2014/4531/P AND 2012/2489/P 50 REDINGTON ROAD
RE APPLICATION PLANNING

The Proposed Work:
Erection of new dwellinghouse comprising three storeys plus excavation of two basement levels, following demolition of existing.

**BASEMENT IMPACT ASSESSMENT
SCREENING REPORT**

**50 REDINGTON ROAD
LONDON
NW3 7RS**

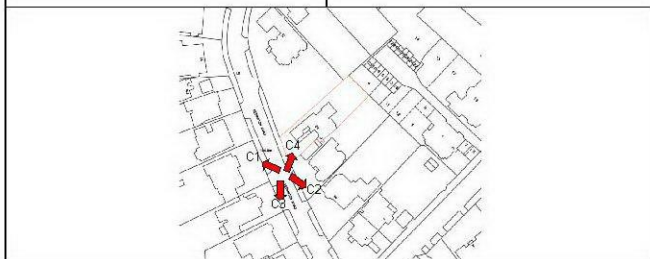
- This is an area of subsidence. I have had movement as per the photos attached. Many area of London are built on clay and any movement will be exacerbated if the houses are built on slopping ground. This is definitely the case of Redington Road
- I am against this development even more so because of the double basement as my neighbour has not shown any information how he will protect the stability of our house.
- I am surprised that the Appeal was granted as the refusal was based on the "Unacceptable Impact on Neighbouring Properties". We were never advised that the Appeal was granted. My architect who registered at the Appeal as an interested party was also not advised
- I have attached previous emails and correspondence I have had with your department.
